**CHAR DEVELOPMENT AND SETTLEMENT PROJECT II**  
**চর উন্নয়ন ও বসতি স্থাপন প্রকল্প ২**  
**BANGLADESH**

**Functioning of Gates of Regulators/Sluices  
and  
Measures for Sustainable Operation & Maintenance  
Under BWDB  
(Special Reference to CDSP-II)**

**Technical Report No. 15b**

**Typical Details for  
Accommodating V.L  
Gates**

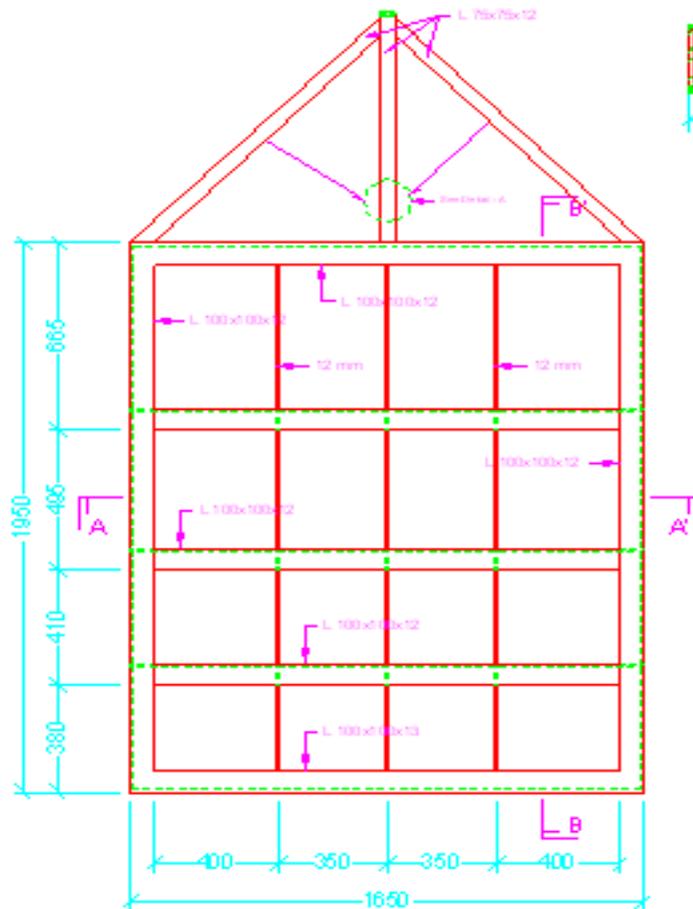
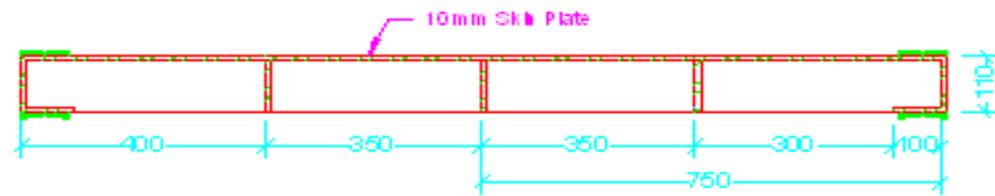
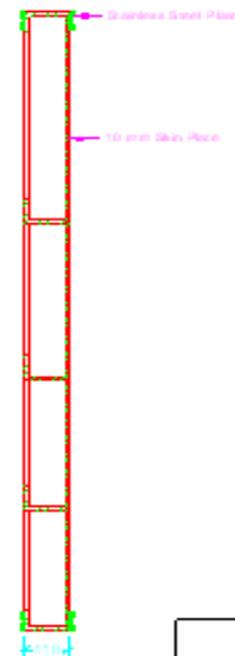
5. The lower end of head wall where the upper end of vertical lift gate rests in closed position, shall be at least 25mm extended than the other part of the head wall as per detail of the standard design manual; that is not strictly maintained.

6. The Channels guiding the vertical lift gate is not always in proper alignment, the embedded frame for vertical lift gate and also for flap gate is not in same plane.

15. The lower end of head wall where the upper end of vertical lift gate rests in closed position, shall be at least 25mm extended than the other part of the head wall as per detail of the standard design manual; Appendix-VIII.

16. A rubber flap, as shown in the sketch may replace the rubber seal at present used for vertical lift gates. The embedded channel may be lined with a stainless steel plate and the gate itself may be provided with stainless steel strip in place of rubber seal. Appendix-VIII.
